**SYDNEY CENTRAL CITY PLANNING PANEL (SCCPP)
COUNCIL ASSESSMENT REPORT**

Panel Reference	PPSSCC-692
DA Number	DA/273/2025
LGA	City of Parramatta Council
Proposed Development	Partial demolition of existing structural elements, the construction of a 16-storey Residential Flat Building with parking, and associated landscaping, public domain works, and infrastructure improvements.
Street Address	No. 10 James Street, Carlingford NSW 2118
Applicant & Owner	Applicant: The Trustee for Captag James Project Trust Owner: Captag James Project Pty Ltd
Date of DA lodgement	10 June 2025
Number of Submissions	Three (3)
Recommendation	Refusal
Regionally Significant Development	Development with a capital investment value of more than \$30 million (\$31,580,716.00).
List of all relevant s4.15(1)(a) matters	• Environmental Planning and Assessment Act 1979 • Environmental Planning and Assessment Regulation 2021 • State Environmental Planning Policy (Housing) 2021 • State Environmental Planning Policy (Resilience and Hazards) 2021 • State Environmental Planning Policy (Biodiversity and Conservation) 2021 • State Environmental Planning Policy (Planning Systems) 2021 • State Environmental Planning Policy

Figure 4: Proposed site plan

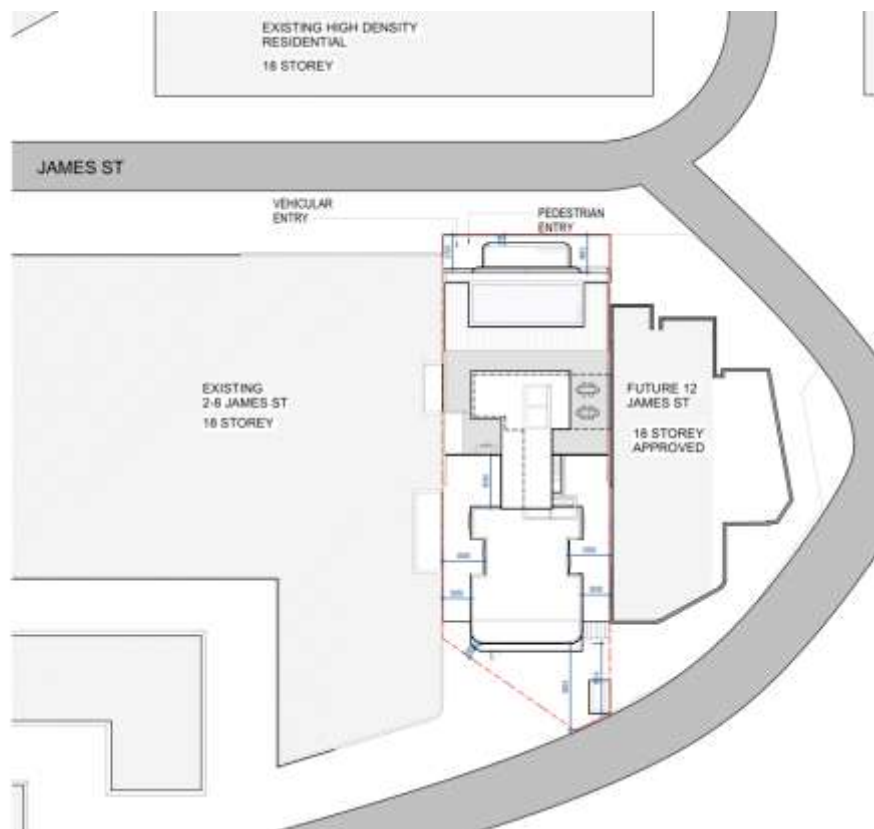
8. Building separation for the rear portion of the buildings is insufficient at 3.05m and at 4.5m at the notch. The high-level windows in bedrooms and bathrooms in the rear 4 bedroom apartments are not effective in eliminating cross-viewing, as occupants of higher levels in adjacent buildings to the east and west are able to look down into the proposed bedrooms and bathrooms. It is noted that the proposed bedrooms have south facing windows which have the potential to comply with the BCA for window areas without creating cross-viewing between neighbouring buildings. It is recommended to remove or make translucent the high level windows in bedrooms and to make windows translucent and operable for ventilation in bathrooms.

15. The landscape plans prepared by Conzept indicate mass planted areas to the front and rear of the site with communal open space located principally on the roof level. This roof open-space incorporates a barbecue area and swimming pool. Given the size and configuration of this primary communal open space, the Panel questions the inclusion of the pool, both for its suitability and for its impact on the communal amenity.

16. The triangle shaped 'leftover' area to the rear of the site is entirely mass planted with Trees and shrubs. Access for maintenance to this area appears to be limited. The Proponent should investigate the opportunity to better integrate the space with the PLR land.
